Delegated Report

Full Planning Application

Application No:	20230065
Location:	48 Arthur Street & 53 Cutmore Street, Gravesend, Kent, DA11 0PR
Description:	Erection of a two storey rear extensions and change of use of the basement to create new commercial unit including new front access and small rear lightwell.
Applicant:	Mr Tony Panaser
Site Visit:	12 th July 2022

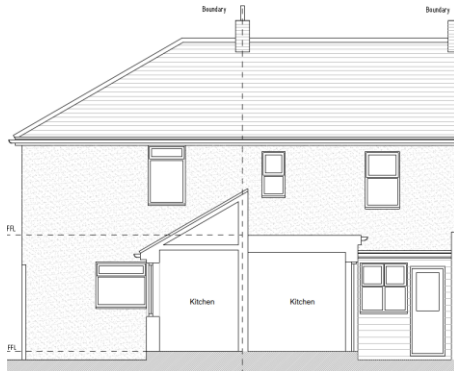
“The extension proposed will not change the overall depth of the existing single storey rear projections, but will notably increase the bulk and massing by creating a first floor which increases the height and width, as well as changing its roof form (see screenshot below):

Gravesham’s Design Guidance SPD (2021) addresses two storey/first floor rear extensions, stating that “extensions to extensions will generally not be supported” and that care must be taken to ensure “the extension does not dominate the original property”, which “can cause the site to appear overdeveloped, and cause long dark internal spaces”. In this case, the extension to the outrigger dominates the original property, is a disproportionate addition that extends an existing extension and as aforementioned results in an overdeveloped appearance. Moreover, the extension will connect with the property at the rear (no. 49 Arthur St) and will have a terracing effect. The extension will close an established gap within the street scene, which is considered poor design and harmful to the character of the area. This gap is replication on the property location on the opposite corner, known as The Cricketers Public House and show in the image below;

The proposal is also creating an undercroft area below the proposed first floor extension which is considered poor design and will appear as an incongruous addition.”

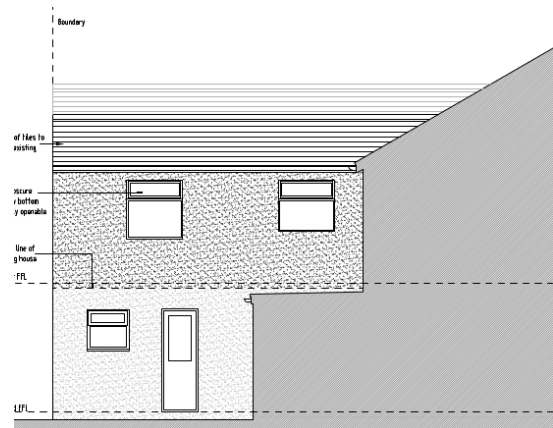
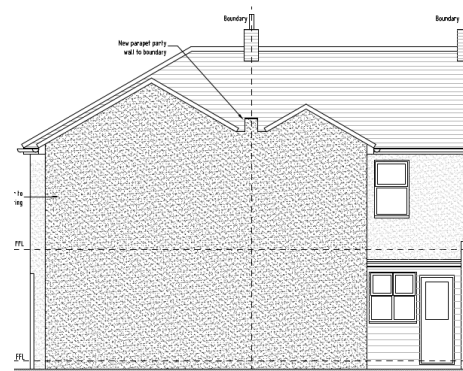
Nevertheless, the extensions are considered to impact on the amenity of future occupiers of no. 53 Cutmore Street. Due to the orientation of the properties and the extension being constructed to the south of the bedrooms 2's window, it would likely overshadow the bedroom to the detriment amenity. The closest window to the extension serves a habitable bedroom. The BRE daylight and sunlight assessment states that a 45° measurement should be taken from plan and elevation drawings, if the 45° line intersects the middle point of the window it would result in unacceptable levels of overshadowing. The tests undertaken are shown below:

As demonstrated in the assessment above, the extension fails the 45° rule on both plan and elevation form, and it would overshadow the bedroom window to an unacceptable level. As a habitable room, the bedroom should not be overshadowed to safeguard amenity of future occupiers, and by virtue of failing the BRE tests the development would provide a poor quality living environment for future occupiers of no.53 Cutmore St and cannot be supported. Moreover, the extension would create a sense of enclosure and provide poor outlook from the bedroom, which would detrimentally affect amenity.

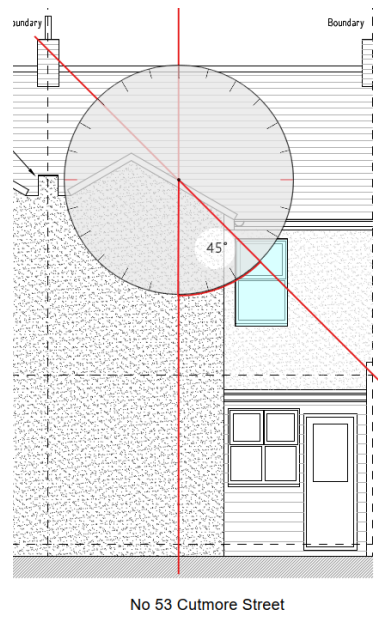
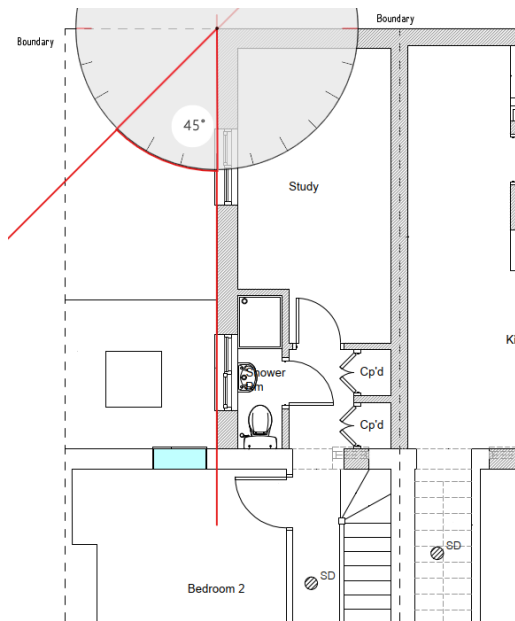
There would be a new lightwell window on the front of the unit and a lightwell at the rear. There are concerns with the quantity of natural light that the commercial occupants of the basement unit would receive. The rear lightwell will be located within the courtyard area, which is an undercroft area covered by the extension above and would provide lower levels of natural light and create a gloomy poor-quality environment. As such, the proposed development will create a poor-quality retail unit, which is detrimental to its viability and function, and is therefore contrary to Policy CS08 (LPCS).
